Access Compliance Report

Public Rights-of-Way

Intersection ID: 48197	Main Street: BLAKENEY PARK DR	Cross Street: ARDREY KELL RD	Location: NE
ADA ID: 4AE8F5E84421	Ramp Type: PerpDiag	Initial Pass/Fail: Fail	Overall Compliance: No
		Severity Score: 10

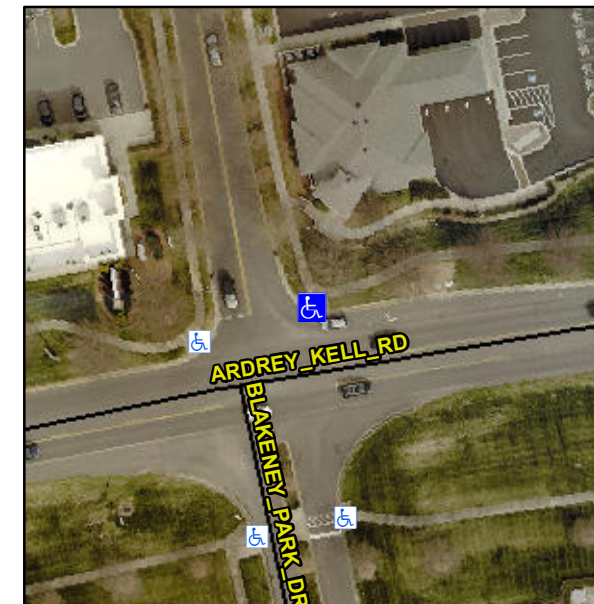
Not Found, R304.5.1, R304.5.3

Compliance	Description	Data	Compliance	Description	Data
N/A	Ramp Length (in)	82.0	Yes	Ramp Slope (%)	8.0
No	Ramp Width (in)	47.0	No	Ramp XSlope (%)	2.4
N/A	Flare Type LT	N/A	N/A	Flare Type RT	N/A
N/A	Flare Slope LT (%)	N/A	N/A	Flare Slope RT (%)	N/A
N/A	Flare Traversable LT?	N/A	N/A	Flare Traversable RT?	N/A
N/A	Landing Length (in)	N/A	N/A	DWS Provided?	N/A
N/A	Landing Width (in)	N/A	N/A	DWS Contrast?	N/A
N/A	Landing Slope (%)	N/A	N/A	DWS Length (in)	N/A
N/A	Landing X Slope (%)	N/A	N/A	DWS Full Width?	N/A
N/A	Landing Curb? (Y/N)	N/A	N/A	DWS Offset (in)	N/A
N/A	Shared Landing?	N/A			
N/A	Gutter Ponding?	N/A	N/A	Gutter Slope (%)	N/A
N/A	Gutter Lip Ht (in)	N/A	N/A	Gutter X Slope (%)	N/A
N/A	Painted X Walk1?	No	N/A	Painted X Walk2?	No
	X Walk 1 Direction	To W		X Walk 2 Direction	To S
N/A	X Walk 1 Width (in)	N/A	N/A	X Walk 2 Width (in)	N/A
	X Walk 1 Slope (%)	0.5		X Walk 2 Slope (%)	0.0
	X Walk 1 X Slope (%)	1.8		X Walk 2 X Slope (%)	0.9

Remove & Replace Curb Ramp With Two New Directional Ramps or Equivalent.
